UNITED STATES
NUCLEAR REGULATORY COMMISSION
REGION II
SAM NUNN ATLANTA FEDERAL CENTER
61 FORSYTH STREET, SW, SUITE 23T85
ATLANTA, GEORGIA 30303-8931

SUBJECT: FINAL SIGNIFICANCE DETERMINATION FOR A YELLOW FINDING AND
NOTICE OF VIOLATION (NRC INSPECTION REPORT NOS.
05000348/2007011 AND 05000364/2007011, JOSEPH M. FARLEY NUCLEAR
PLANT)

Unit 2 RHR MOV 8811A Preliminary Yellow Finding

Cause Evaluation (continued)

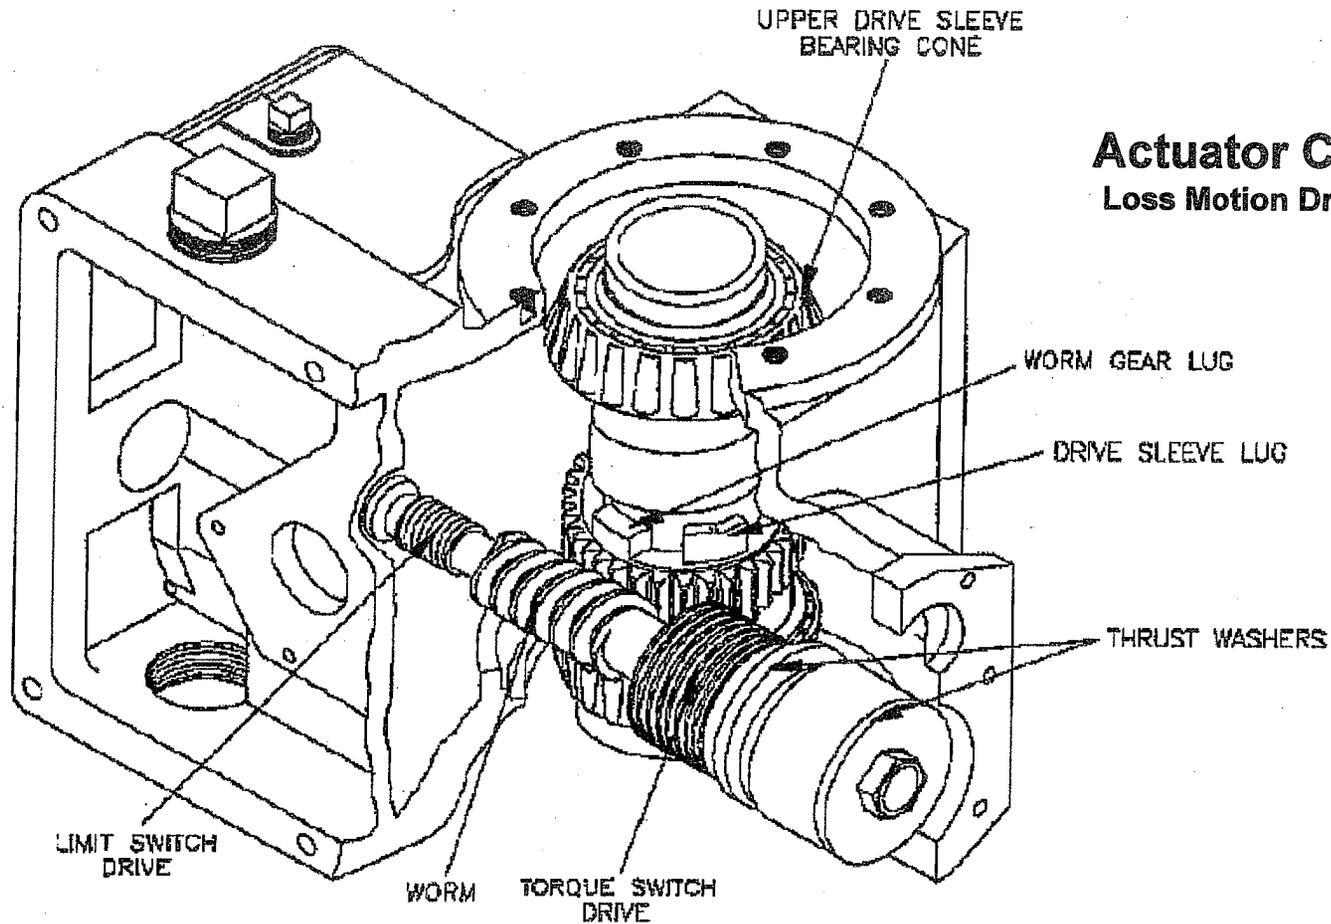
- ◆ Identified failure mechanisms:
 - Hammerblow effect of opening valve
 - OEM-identified contact guide pitting

- ◆ **Bottom line:** Identified failure mechanisms, acting in concert, caused Unit 2 MOV 8811A valve function issue, and are not associated with other encapsulated valves.

Torque Switch Displacement – Hammerblow

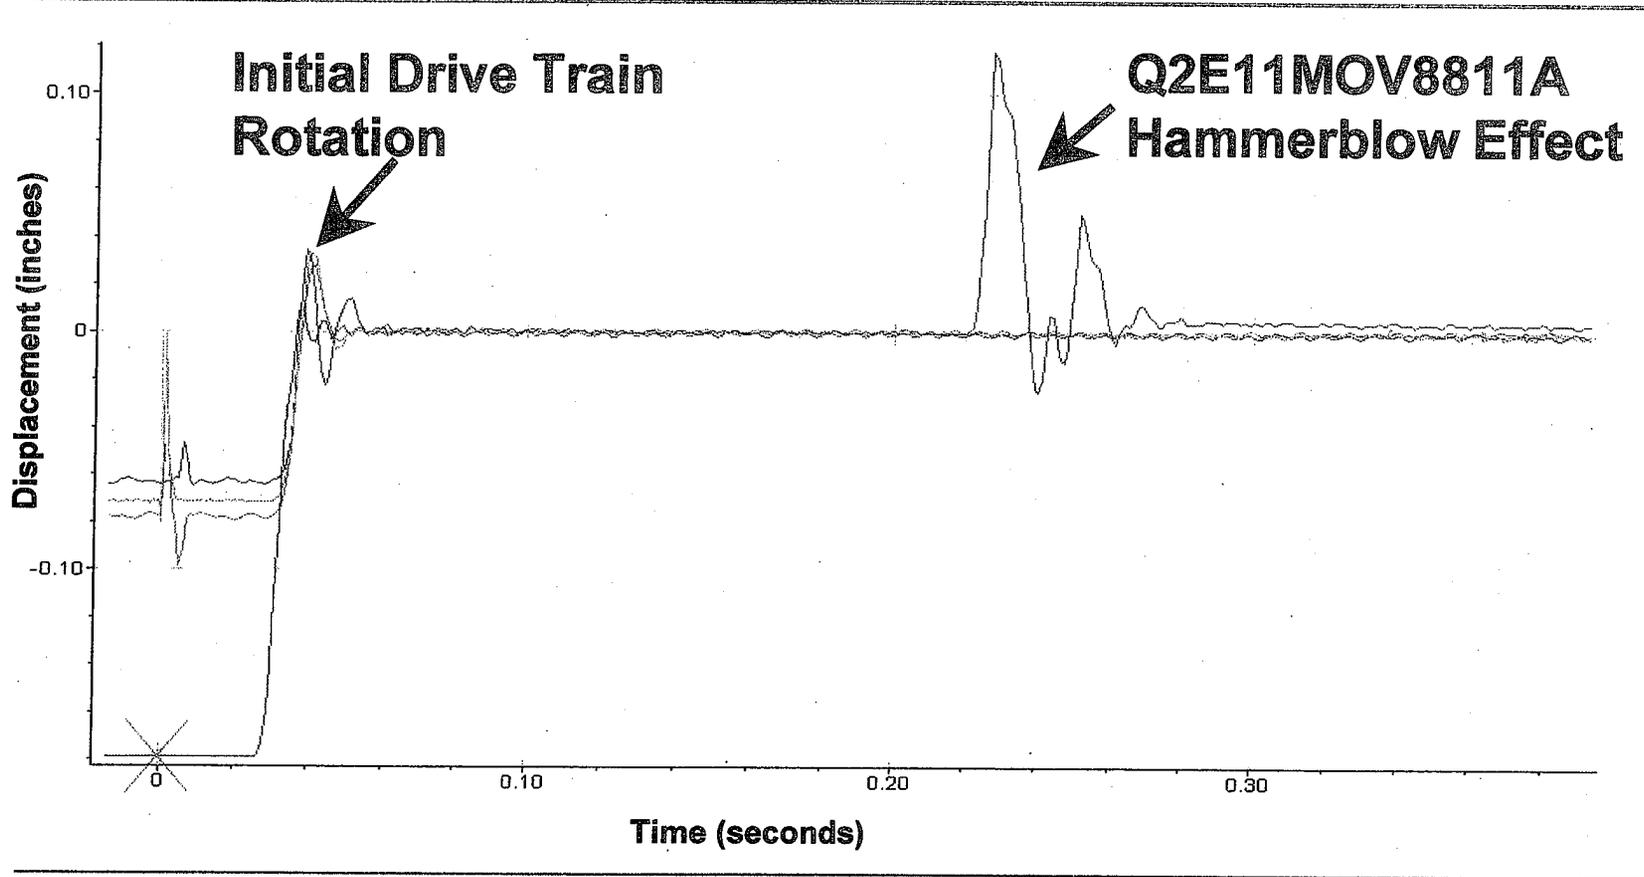
MOV 8811A as compared to MOVs 8811B, 8812A and 8812B open spring pack displacement.

- ◆ Root cause is Hammerblow forces placed on the torque switch, in concert with pitted area on the contact guide.
- ◆ Unit 2 MOV 8811A has a unique actuator configuration and operational response, as compared to Unit 2 MOV 8811B and all other encapsulated valves on both units.
- ◆ No motor degradation other than ordinary wear identified.
- ◆ Therefore, the other RHR Train suction Valve (MOV 8811B) would not be affected by a Common Cause.

In response to SNC's perspectives, the NRC considered the following in assessing the final significance of the finding. With regard to SNC's position that the valve failures were independent, the NRC was not able to exclude common cause. During the conference, SNC stated that the Unit 2 RHR Train A containment sump suction valve was different from other similar valves in that it was susceptible to a "hammer blow" affect on opening, which contributed to the valve failure. Additionally, SNC stated that they identified pitting on the torque switch open contact guide. SNC further stated they had not determined the cause of the pitting but could not eliminate corrosion as a factor. Based on information provided during the conference, the NRC concluded SNC had demonstrated that the "hammer blow" affect appeared to be limited to the RHR Train A containment sump suction valve. However, based on the results of our inspection, and the identification of a high humidity environment inside the valve encapsulation resulting in rust and corrosion, the NRC could not eliminate the environment as a potential common cause for failure of other valves in similar environments. An independent failure is defined such that the failure cause must be well understood with no possibility that the circumstances existed in other components in the common cause group. The NRC was unable to conclude that the potential coupling mechanism (e.g., the environment within the encapsulation) was irrelevant to the valve test failures. In addition, the cause of the test failures was not well enough understood to eliminate any possibility that the other encapsulated valves could fail under similar circumstances. Consequently, common cause failure was retained in the NRC's final numerical risk quantification.
